Product Change Notification – Major change

PCN #: PCN25-0042	Rev: 1.0	Issue Date: May 01, 2025																								
Purpose of notification: New manufacturing location, marking and balling enhancement for 100-ball eMMC Type of notification: Major change																										
Detailed Description: <p>As part of Swissbit's commitment to continuous product / process improvement, Swissbit has introduced fully integrated in-house manufacturing of its embedded eMMC product line EM-3x, 100-ball.</p> <p>Swissbit's in-house manufacturing site is located in Berlin, Germany and ensures higher supply chain resiliency and offers our customers enhanced quality assurance standards and controls.</p> <p>EM-3x products manufactured in our facility have been fully qualified and are assured to meet or exceed all performance, endurance and reliability metrics.</p> <p>With in-house production capability, we improve from 'batch traceability' to 'item traceability' by adding a data matrix code on the front. This code is also needed for the "digital product pass" (DPP 4.0), which will become mandatory soon. On the back side, corrosion resistancy is improved by covering non-functional contact surfac

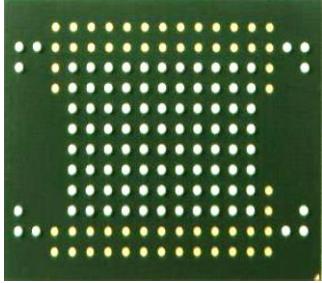
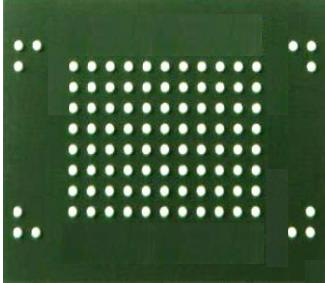
<table><tr> <th></th> <th>Manufactured in Taiwan</th> <th>Manufactured in Germany</th> <th>Description</th> </tr><tr> <td>Front side (Laser marking)</td> <td>  </td> <td>  </td> <td>Improved traceability Taiwan: batch based traceability Germany: item based traceability</td> </tr></table>

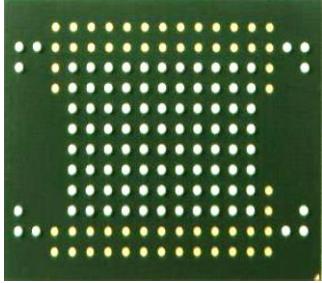
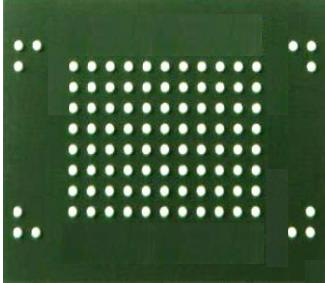
<table><tr> <th></th> <th>Manufactured in Taiwan</th> <th>Manufactured in Germany</th> <th>Description</th> </tr><tr> <td>Back side (Test pads)</td> <td>  </td> <td>  </td> <td>Test pads (yellow dots, no functionality for customer) Taiwan: open test pads Germany: covered test pads</td> </tr></table>
